Proposed Travelodge Stockley Park

Design Response

This brief report has been prepared to analyse and address the comments made by the Design Officer in relation to the submitted application for the conversion of an existing redundant public house and office space to a Travelodge and Bar Café.

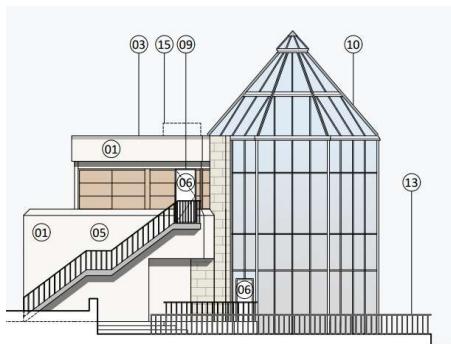
JWA Architects have reviewed the Design Officers comments and have replanned the ground floor and first floor layouts of the proposal to ensure that all 6 of the existing concrete columns on the north elevation are retained and not suppressed into the elevation and thus retaining the strong vertical presence the columns offer. The new wall line will follow the line of the existing wall.

The previous scheme incorporated the new entrance into a rendered element of walling which has now been reduced and the proposed render removed from the palette of materials proposed.

To retain these columns and ensure that the feasibility is sustainable in relation to bedroom numbers we had to revise the ground and upper floor layouts providing a small extension on the ground floor to accommodate the back of house operations.

All the existing concrete columns will be cleaned down and emphasized as part of the main feature of the building elevation along with the top horizontal concrete cladding and its associated connection.

The small extension at ground floor is proposed to be clad in a stone cladding and samples of these materials will be provided under separate cover. Photo's of the concrete cladding samples are attached at the end of this report. The stone cladding to the extension will wrap round the single storey extension onto the western elevation.

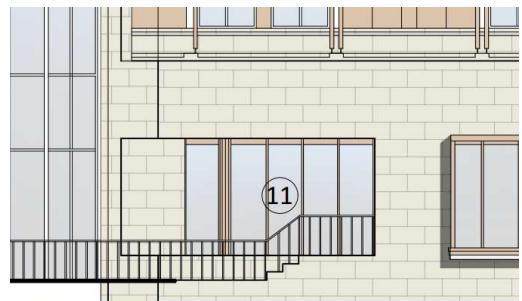
On the north elevation the scheme requires the removal of the timber cladding due to the new floor area and the condition of the timber and its flammability.

The location of the new extension at ground floor sits approximately in the same area as the current screened bin store which projects past the front building line of the building.

Due to the restrictions and the new purpose group of the building being of a sleeping risk the requirement for non-combustible cladding is required. We have investigating a number of non-combustible timber effect cladding panels and photos of a sample are attached at the end of this report. The new cladding system will be designed to reflect the existing rhythm of the building elevation. It should be noted that at least half of the existing elevation is glazed with infill panels not all timber

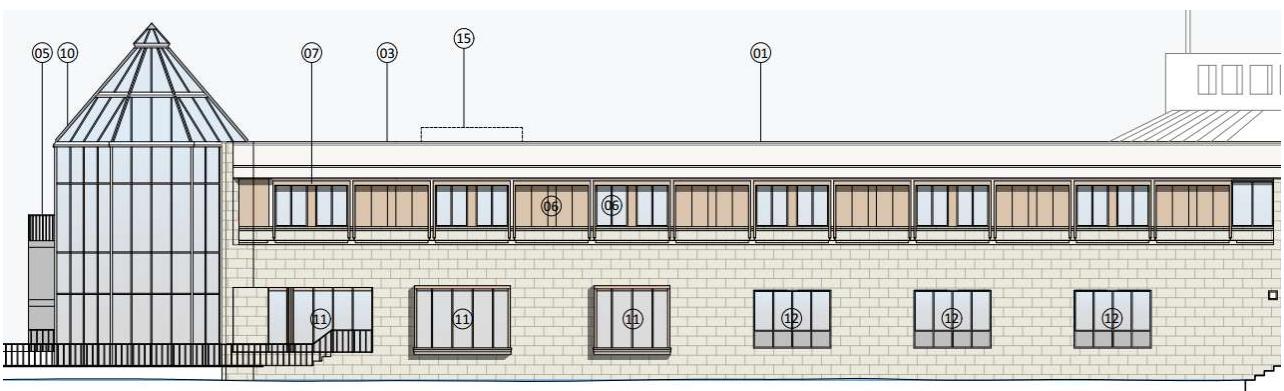
The south elevation facing onto the lake will now retain its existing recessed balcony adjacent to the rotunda thus retaining the existing feature.

With regards to the additional windows required for the four new bedrooms these will be designed to correlate with the existing window opening sizes maintaining the same vertical proportions as the bay windows as well as coursing. These windows will match the replaced windows in material being a colour coated aluminium which will be designed to match the existing.

The timber on the upper floor elements of the south elevation will again be replaced due to the flammable content of the wall and the cladding system will be to match the north elevation.

The timber vertical support at first floor level will be retained as this does not form part of the external wall construction.
